17 December 2024

Receipt of a Private Plan Change Request at 40 Mahi Road, Helensville and a Request for Further Information Pursuant to Clause 23 of the Resource Management Act 1991

Appendix A

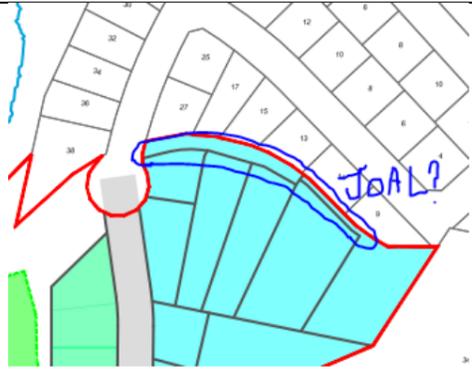
E6	Please clarify what is anticipated to occur to meet Policy I55X.3(5) in the proposed precinct provisions.	Policy I55X.3(5) states that all riparian margins across both zones will be planted with indigenous vegetation, and that buffers will also be planted around the edge of the existing indigenous vegetation at the site. However, there is no further mention of this requirement in the rest of the document, or in the Ecological Assessment. The planting requirements proposed elsewhere in the precinct provisions are also somewhat contradictory as Standard I55X.6.4.2(1) restricts planting to “the riparian margins of any permanent or intermittent stream <i>within the SHZ</i> ”, while the matters of discretion of restricted discretionary activities state that “any development or subdivision adjacent to intermittent or permanent watercourses as shown on the Precinct Plan must provide 10m riparian planting either side of the watercourse” (implying that this requirement also applies to streams outside the SHZ).

The Ecological Assessment indicates that no intermittent or permanent streams occur within the SHZ, meaning that no riparian planting would be required under Standard I55X.6.4.2(1) (see Question 2 above seeking clarification on this point), so it is not clear how the requirement in the matters of discretions would be triggered. The Ecological Assessment states that planting would be required in the CLZ where the SHZ extends within the 20-metre-wide margin that would usually be required adjacent to Stream 1, but this is not clearly provided for in the precinct provisions.	
E7	Please provide an assessment of the potential ongoing effects on indigenous fauna of the urban development that will result from the proposed plan change.	The Ecological Assessment focuses on potential direct effects on indigenous fauna that may result from the proposed rezoning (such as harm to lizards resulting from vegetation removal and earthworks activities). However, there is no discussion of the potential ongoing effect of the resulting urban development on indigenous fauna. Such an assessment should be provided and should include (but not be limited to): <ul style="list-style-type: none"> • Effects of lighting disturbance to long-tailed bats using the area for commuting, foraging, and roosting. • Effects of domestic pets (particularly cats) on indigenous fauna residing in the indigenous vegetation to be retained at the site. Precinct provisions to manage on-going effects of nearby urban development on indigenous fauna should be provided.
